ON-SITE SEWAGE DISPOSAL SYSTEM
HOWARD COUNTY HEALTH DEPARTMENT
BUREAU OF ENVIRONMENTAL HEALTH

ADDRESS: 12139 Old Frederick Road TAX ACC'T #: _____

PLOT PLAN
SHIPLEYS CHOICE
LOT 1

RE: Shipley's Choice Lot 1
12139 Old Frederick Road
B13001355

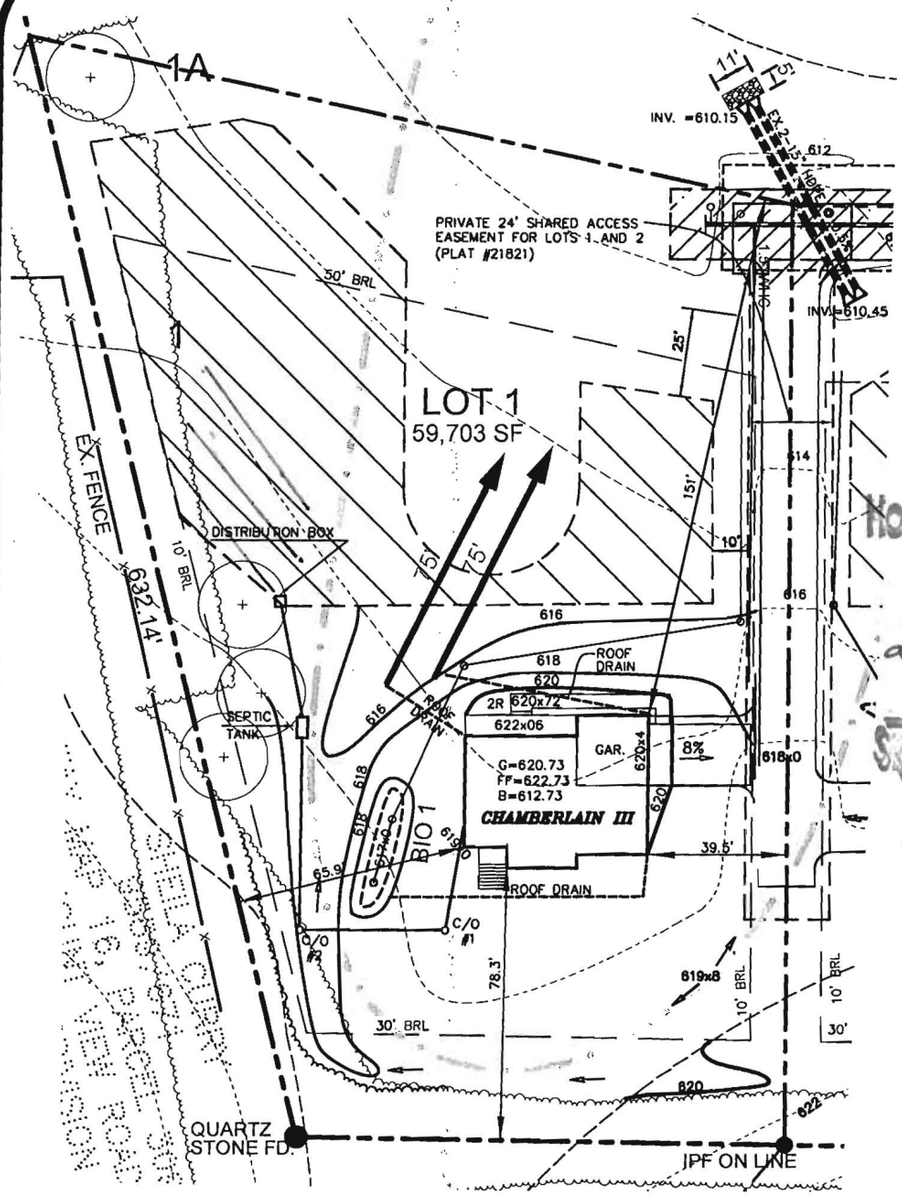
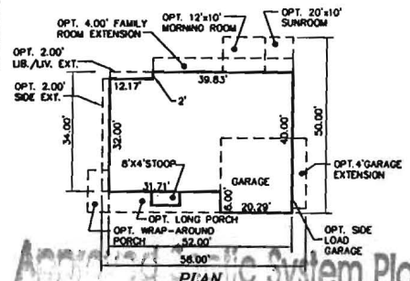
PRE-CONSTRUCTION:
6/18/2013 (AM) Gas main ruptured. Layout cancelled by firemen. BB
6/18/2013 (PM) Install an upper 60' and lower 100' trench on contour across the top of the western part of the septic easement. Install the tank near where shown on the B.P. plan. BB

REVISED
Date: 6-6-13
Comments: per Health

REVISED
Date: 4-29-13
Comments: revised plot per Health

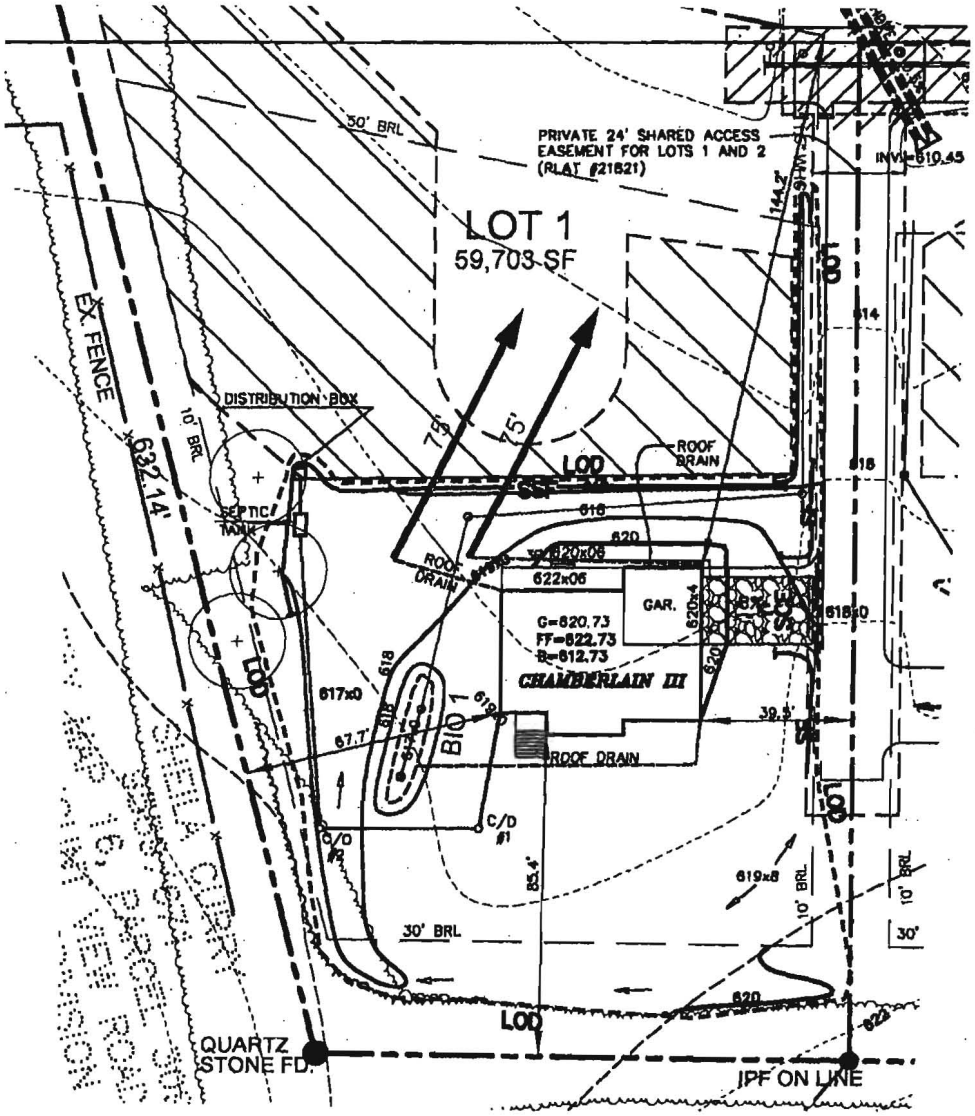
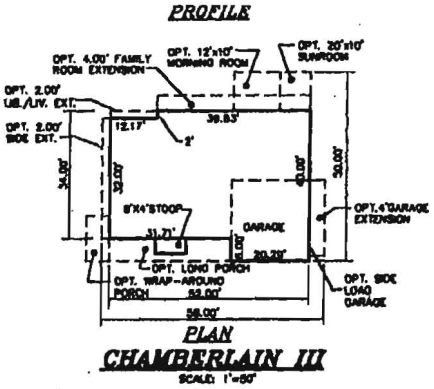
The following is a response to your comments dated April 24, 2013.

1. To maintain a minimum cover over the sewer line from the proposed building to the septic tank the suggested revision is not possible. Cover over the sewer line would be 2.5' max. Also there would be a conflict with the crossing between the sewer line and the outflow pipe from the bio-retention facility; therefore SHC has not been revised.
2. Discharge points from the roof drains have been relocated to be at least 20' from the septic easement.
3. Please note that the outflow pipe from the bio-retention facility runs along the septic area,and the driveway, and the discharge point is behind the SDA.

There is no flexibility in the required 10 feet separation from a pressurized water line to the SDA. A Percolation Certification Plan revision is needed. After observing the characteristics of the area, I think it is OK to remove as much as a 5-foot width from the SDA boundary next to the driveway, then add that area to the boundary represented by percolation test locations '1A' and '3' (see attached graphic).
Robert Bricker, REHS/R.S.

Water house connection and the discharge point from the bioretention facility shown on the plat plan is based on the approved plans.
Since the discharge point is downstream from the SDA I was under the impression that this rule doesn't apply. However, I can extend the outflow pipe from the bioretention farther to meet 25' distance from the SDA.

The water main and WHCs are constructed per approved plans. I can extend the WHC up to the proposed house. Since the distance between the septic easement and UIC driveway is 8', and the WHC will be placed within this area outside the pavement I cannot achieve the 10' separation.
